Access Compliance Report

Public Rights-of-Way

(Curb Ramps)

Intersection ID: 44704	Main Street: MARY_BLAIR_LN	Cross Street: PATRIOTS_POINT_LN	Location: E
ADA ID: BBEA3C46C727	Ramp Type: PerpDiag	Initial Pass/Fail: Fail	Overall Compliance: No
		Severity Score: 8.75

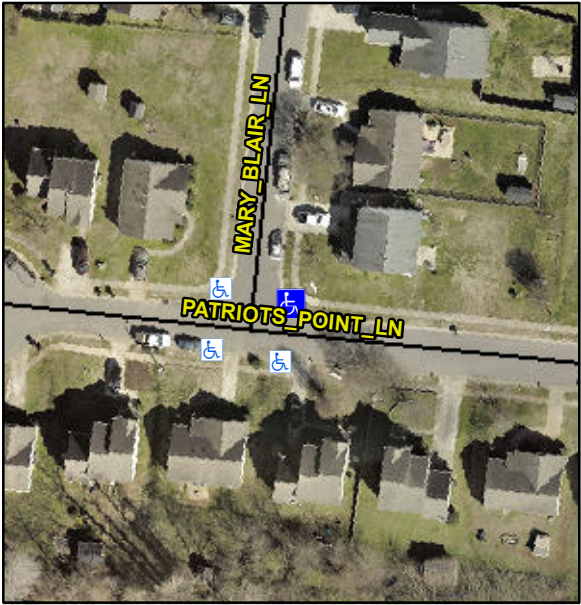
Codes/Mitigation Info/Possible Solution		Field Measurements/Component Compliance			
	Possible Solutions:				
	Remove & Replace Curb Ramp With Two New Directional Ramps or Equivalent.				
	Surveyor Notes:				
	N/A				
	PROW/ADA:				
	Not Found, R304.5.1				
		Compliance	Description	Data	Compliance
		N/A	Ramp Length (in)	47.0	Yes
		No	Ramp Width (in)	39.5	Yes
		N/A	Flare Type LT	N/A	N/A
		N/A	Flare Slope LT (%)	N/A	N/A
		N/A	Flare Traversable LT?	N/A	N/A
		N/A	Landing Length (in)	N/A	N/A
		N/A	Landing Width (in)	N/A	N/A
		N/A	Landing Slope (%)	N/A	N/A
		N/A	Landing X Slope (%)	N/A	N/A
		N/A	Landing Curb? (Y/N)	N/A	N/A
		N/A	Shared Landing?	N/A	N/A
		N/A	Gutter Ponding?	N/A	N/A
		N/A	Gutter Lip Ht (in)	0.5	N/A
		N/A	Painted X Walk1?	No	N/A
			X Walk 1 Direction	To W	
		N/A	X Walk 1 Width (in)	N/A	N/A
			X Walk 1 Slope (%)	2.3	
			X Walk 1 X Slope (%)	3.5	
		N/A	Ramp inside XWalk1?	N/A	N/A
			Road Slope (%)	1.2	N/A
			Road X Slope (%)	3.3	N/A

N/A	Any Obstructions?	N/A	N/A
			Obstruction Type		
				N/A	N/A
				Yes	Surface Condition? (G/P)
					Good
